ADDENDUM NO. 2

PROJECT: **Alden Bridge Sports Park Phase 1**

FROM: Tyler Eaton, PE
Halff Associates, Inc.
14800 St. Mary's Lane, Suite 160
Houston, TX 77079

SHEET NUMBER:
C7.03

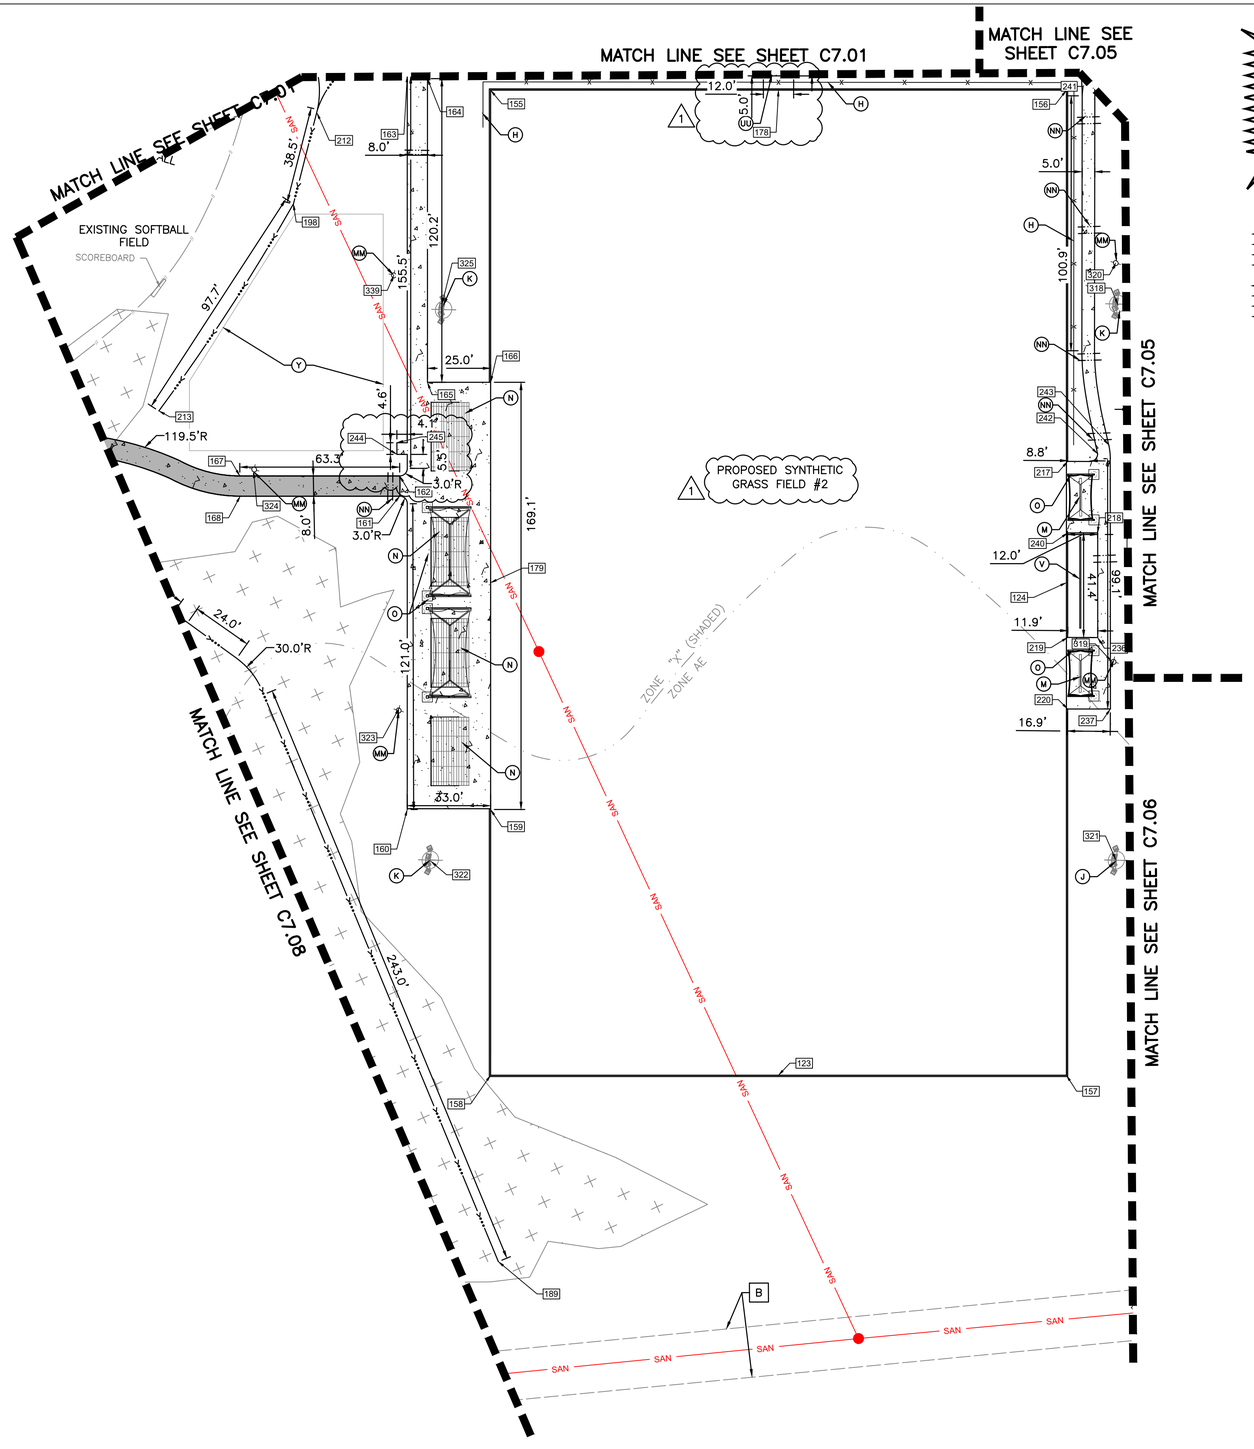
- C7.03 Paving and Dimensional Plan- Detail 'C' has been added to this sheet showing seawalls, retaining walls, ADA ramps and stairs that have been added to make the grades work. Keynotes associated have been added, N/E's, sidewalk hatching and dimensioning have been updated within this area.

SHEET NUMBER:
L2.00

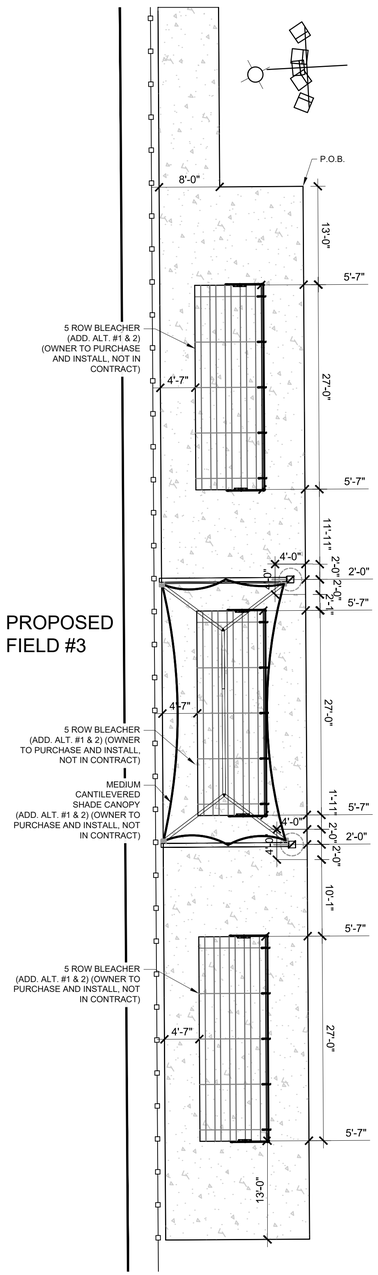
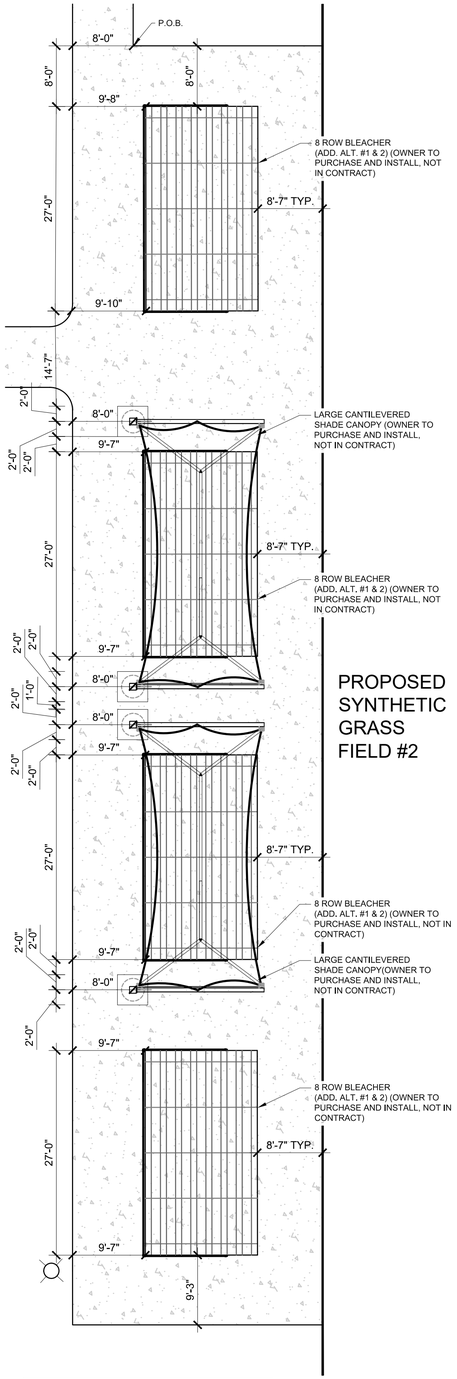
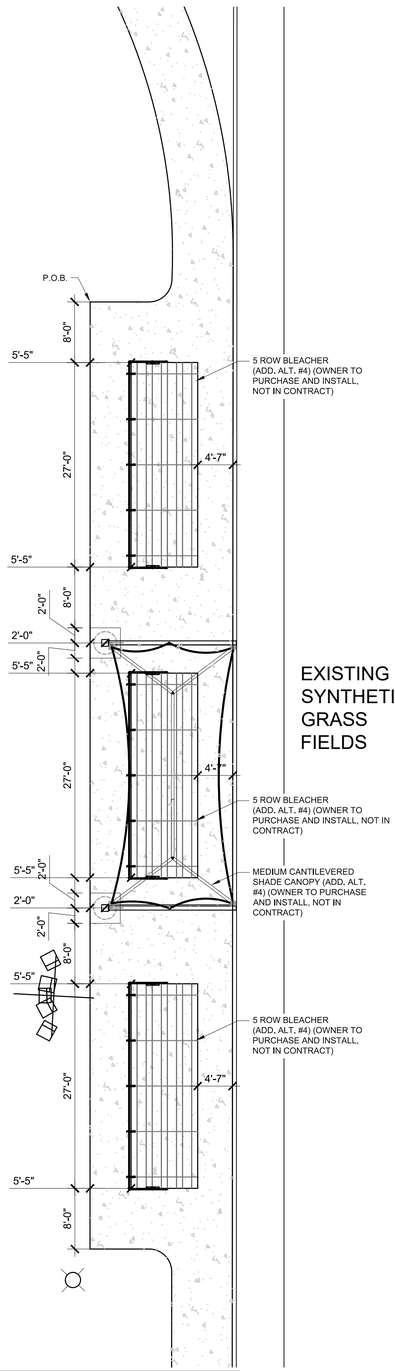
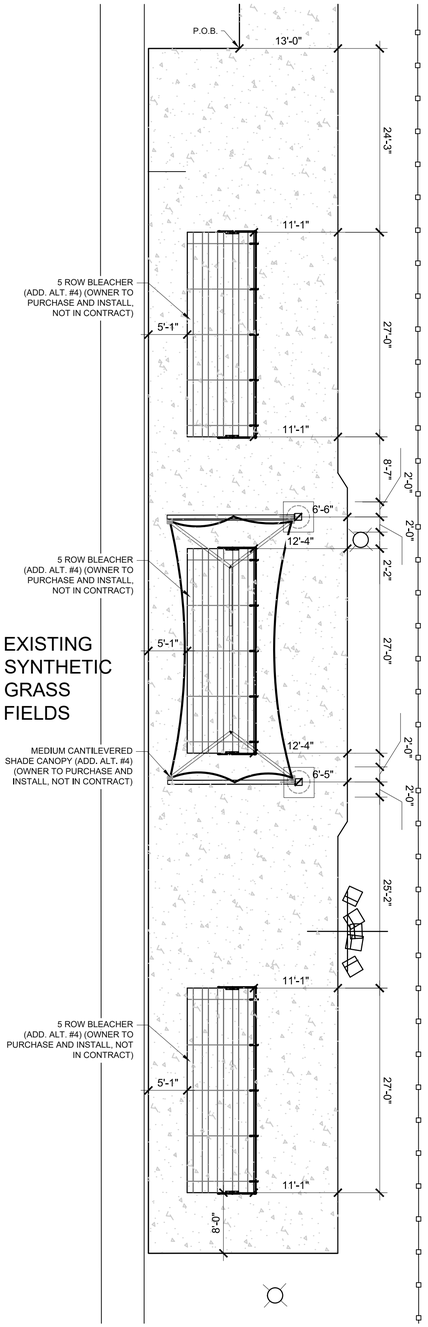
- Sheet L2.00 Site Furnishing Enlargements - Labels for “artificial turf” have been updated to read “synthetic grass.” Labels for shade structures updated to clarify they will be purchased and installed by owner. 4’x4’ leaveouts added to bleacher pad and team bench pad for future shade structure install by owner. Dimensions have been updated respectively.

1 FLAGPOLE FOOTING PLAN

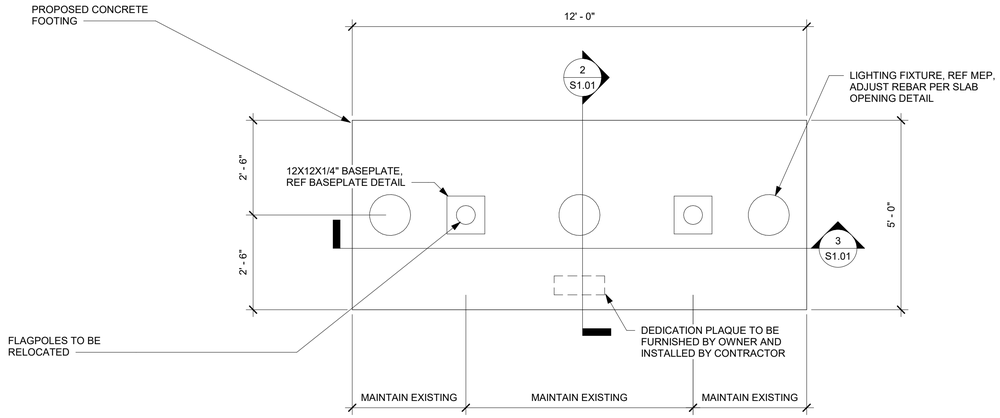
- Sheet E4.03 Electrical Details III: Detail 05- Lighting Contractor Control Schematic added
- Sheet S1.01 Flagpole Base Details – Added foundation and reinforcing design details for flagpole.
